Applies To: 2000-03 3.2TL - See VEHICLES AFFECTED
 2001-03 3.2CL - See VEHICLES AFFECTED

May 26, 2003

PCM Replacement: 3.2TL and 3.2CL

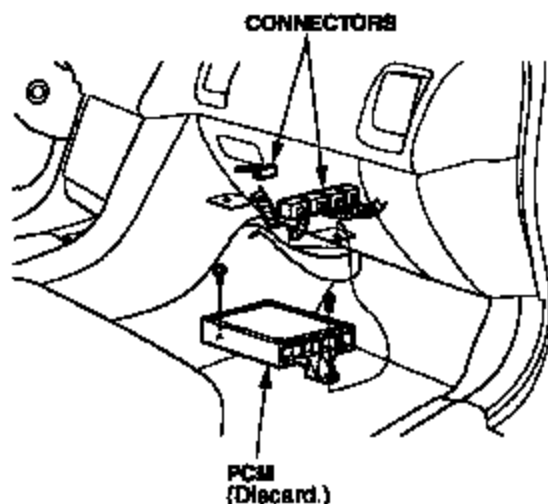
1. If you received a new fuel pressure regulator to repair *this* vehicle, remove and discard the existing regulator, and install the new one. For 3.2TLs, refer to page 11-173 of the 1999-03 3.2TL Service Manual. For 3.2CLs, refer to page 11-187 of the 2001-03 3.2CL Service Manual.

NOTE: The new fuel pressure regulator has a black dot on top to help you identify it.
